## Product Change Notification / JAON-19SJPJ307

CCB 4398.001 Final Notice: Qualification of MMT as an additional assembly site for selected Atmel ATSAML10D1xA, ATSAML11D1xA, ATSAMD11D14A, ATSAMD10D1xA, ATSAMD09D14A and ATMPS001D14A device families available in 24L VQFN (4x4x0.9mm) package.

**CCB 4398.001**  
**Pre and Post Change Summary**  
**PCN #: JAON-19SJPJ307**

# Lead frame Comparison

## Pre Change ASE / ASCL

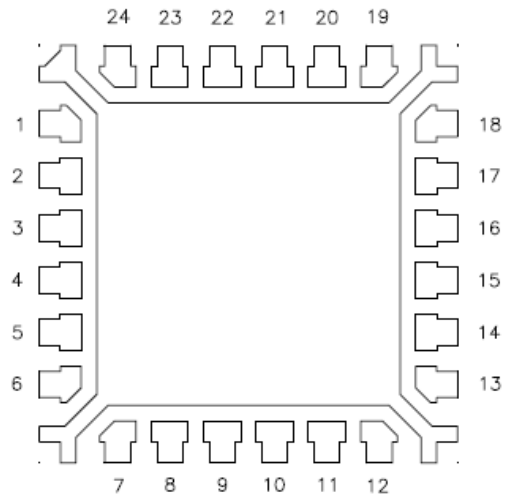
ASE	ASCL
LF Paddle Size	110x110	114x114
DAP Surface Prep	Ag Plated	Double Ag Ring Plated
Lead-Lock	No

## Post Change MMT

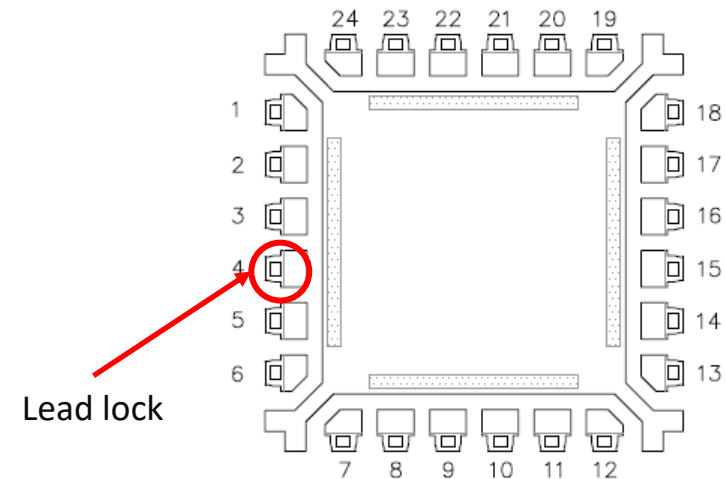
LF Paddle Size	114x114
DAP Surface Prep	Ag selective plated
Lead-Lock	Yes

Note: The lead lock hole fills with mold compound during the assembly process and provides improved protection against moisture penetration around the interface edges between pins and mold compound.
